**CITY OF HAPEVILLE
ECONOMIC DEVELOPMENT DEPARTMENT
PLANNING COMMISSION APPLICATION**

Village at Hapeville – Comment Response Letter – March 6, 2019

Construction Plan Set For:
Village Walk at Hapeville
 Land Lots 98 & 127, 14th District
 City of Hapeville, Fulton County, Georgia

Sheet No.
C-1

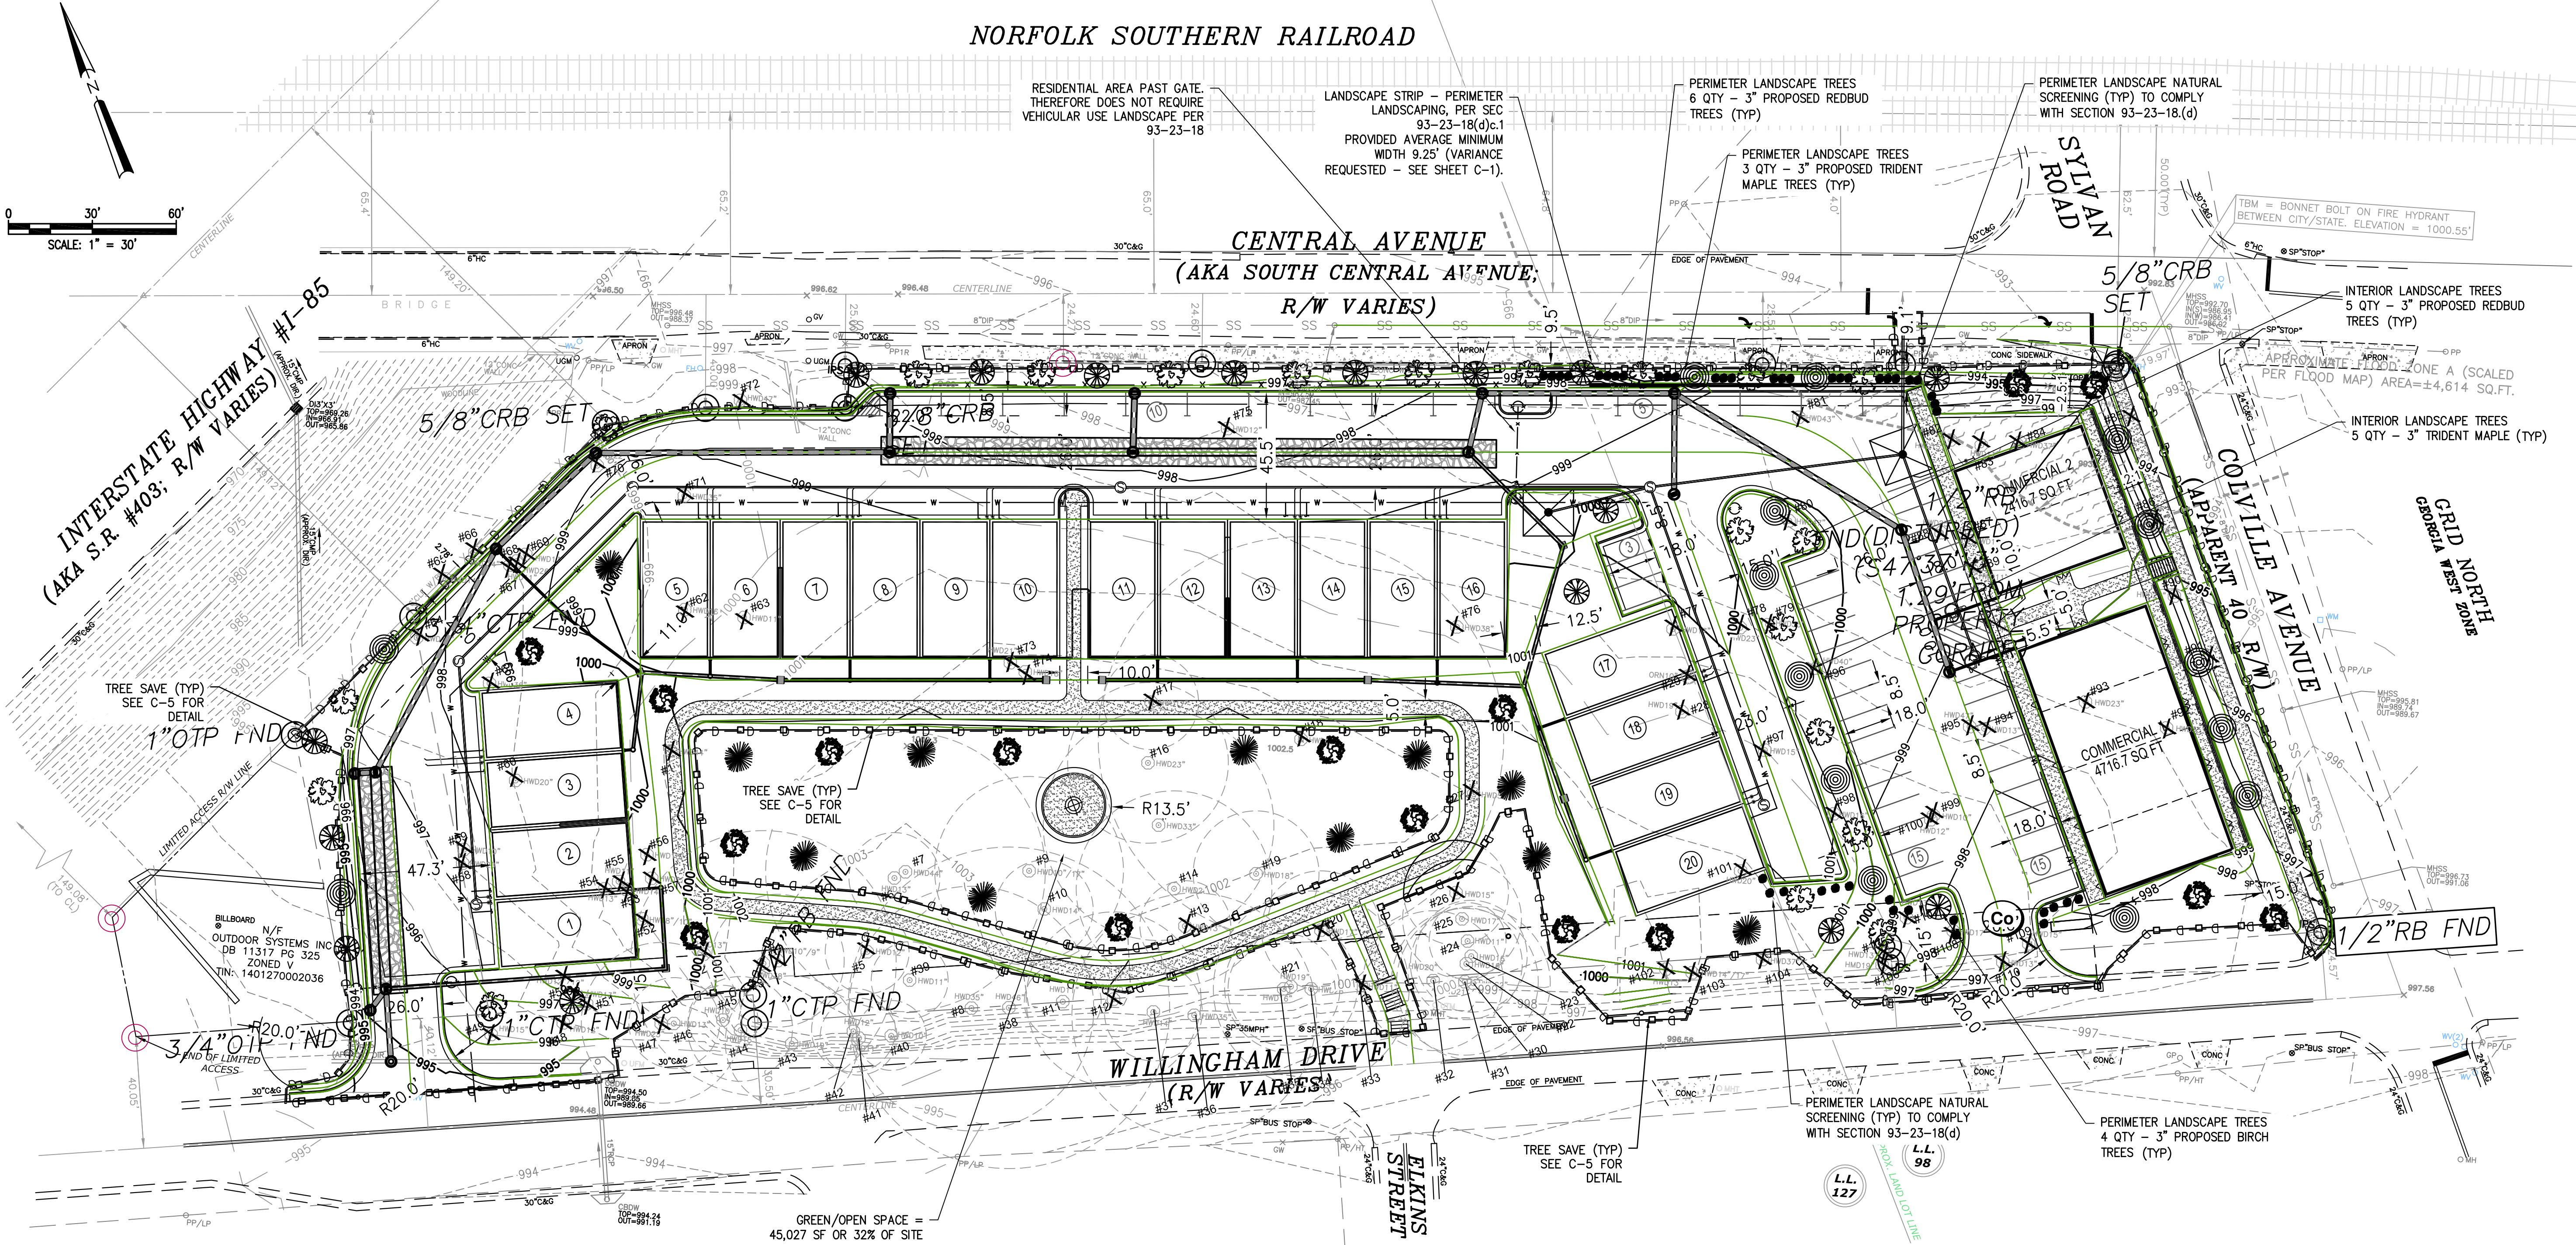
1. This project will require that all access roadways will have to be 26 feet wide.

6. The requested setback to 10 feet along Willingham Road described in the Zoning Dialog Box table does not agree with the 15 feet setback lines shown on the site plan.

CVE Response: The pavement is 6"-2"-1.5" standard as labeled on C-1.

16. The location of the parking spaces for the residential units should be shown on the site plan.

17. Size and location of off-street loading spaces per Section 93-23 should be shown.

31. Parcel ID Numbers are not provided on the site plan (14 012700020429 and 14 012700020379).

32. LL 89 is mislabeled on the site plan (shown as 98)

33. Townhome setbacks: Townhome #1 encroaches on the front 15' setback requirement, at 11.5'. Townhome #20 is on the setback line and may not accommodate for roof eaves. Elevations are not provided to determine. Townhomes #1-3 encroach in the side setback unless the plan is to re-subdivide the parcels into one property. Rear setbacks are compliant.

34. Commercial setbacks: front setback appears to be compliant with a minimum setback of 15'. Commercial #1's south setback encroaches on the south side 15' setback.

47. A dumpster is shown on the northeast side, but it is unclear if this accommodates both residential and commercial.

49. Signage is shown on southeast corner of development. No size is provided.

56. Parking along Colville is within 5' of the property line, but designed as on-street parking. This would require a variance.

58. Size and location of off-street loading spaces is not provided.

CVE Response: See revised site plan with all access 26 feet wide.

CVE Response: Site plan is updated to show buildings within the 15-foot setbacks.

CVE Response: See the site plan for all Parking spaces.

CVE Response: Size and location are shown on the site plan.

CVE Response: The parcel id's have been added to the plans.

CVE Response: The LL has been updated.

CVE Response: The property will be combined to one parcel and the site plan now

CVE Response: All buildings are within the 15' setbacks.

CVE Response: The dumpster will accommodate both residential and commercial.

CVE Response: The sign is shown as 14 foot wide. The architectural plans will show more detailed signage drawings during permitting.

CVE Response: See site plan as the parking is now designated as off-street parking.

CVE Response: one 15 foot by 60 foot loading space is located along Central Avenue north of the commercial 2 building and the dumpster.

Sheet No.
C-5

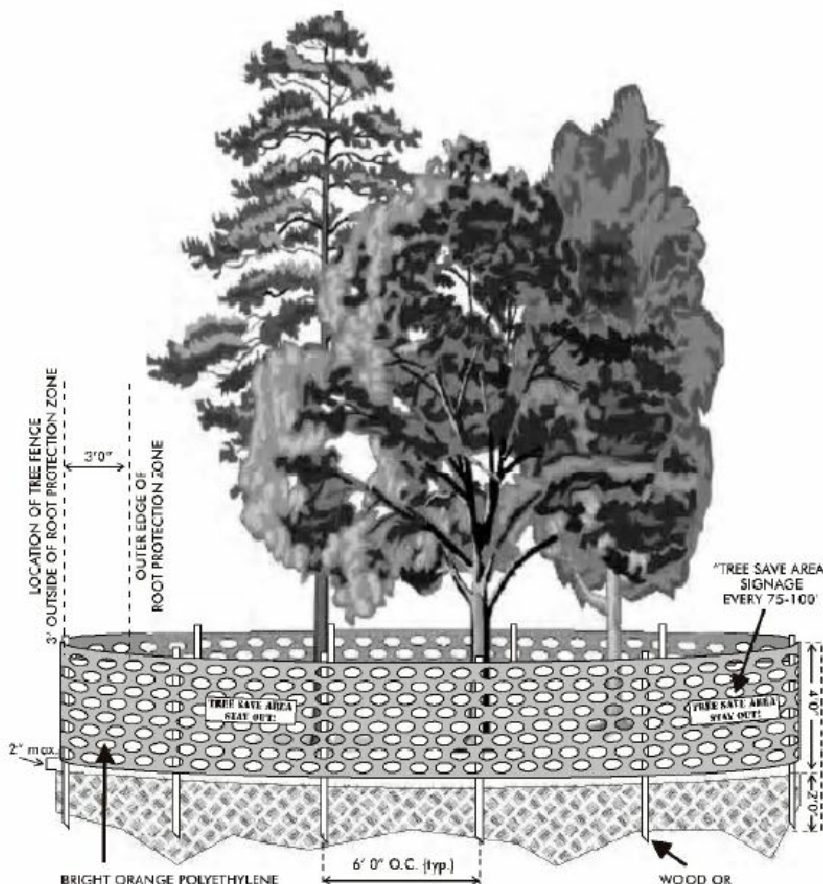
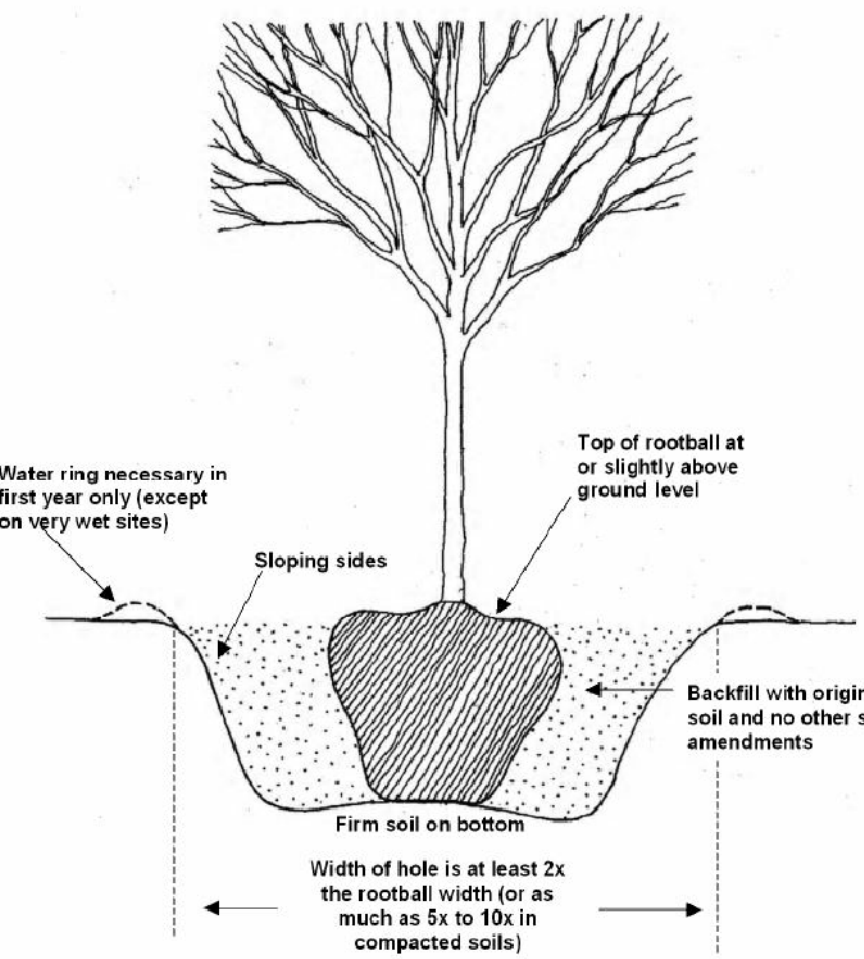
15. The location and approximate size of all proposed plant material used in landscaping should be included per Section 93-2-16(c)(1).f. of City Code.

21. Provisions demonstrating compliance to the Tree Conservation Ordinance requirements per Section 93-2-14 and Landscaping per Section 93-2-16 (c) (1) were not included with the submittal.

22. The site improvements do not include landscaping for the parking areas to address the landscaping for vehicular use areas requirements of Section 93-23-18 of the Zoning Ordinance. The petitioner should clarify.

43. The location and general type of all existing trees over six-inch caliper and, in addition, an identification of those to be retained.

44. The plan does not include compliance with the Tree Conservation Ordinance.

45. The location and approximate size of all proposed plant material to be used in landscaping, by type such as hardwood deciduous trees, evergreen trees, flowering

trees and shrub masses, and types of ground cover (grass, ivies, etc.). Planting in parking areas should be included, as required in section 93-23-18.

46. Site proposes 3 new 3" red maples, 5 new 3" river birches, and 3 new 3" Georgia oaks. No other landscaping detail is provided. There is no perimeter landscaping shown on the South Central Avenue side.

55. The site plan does not consistently include a 15' landscaped buffer between residential and non - residential uses, including along South Central Ave.

CVE Response: A landscape plan is provided as part of this submittal.

CVE Response: A landscape plan is provided as part of this submittal.

CVE Response: A landscape plan is provided as part of this submittal.

CVE Response: See Newly Provided Landscaping Plan as part of the submission

CVE Response: See Newly Provided Landscaping Plan as part of the submission

CVE Response: See Newly Provided Landscaping Plan as part of the submission

CVE Response: See Newly Provided Landscaping Plan as part of the submission

CVE Response: See Newly Provided Landscaping Plan as part of the submission
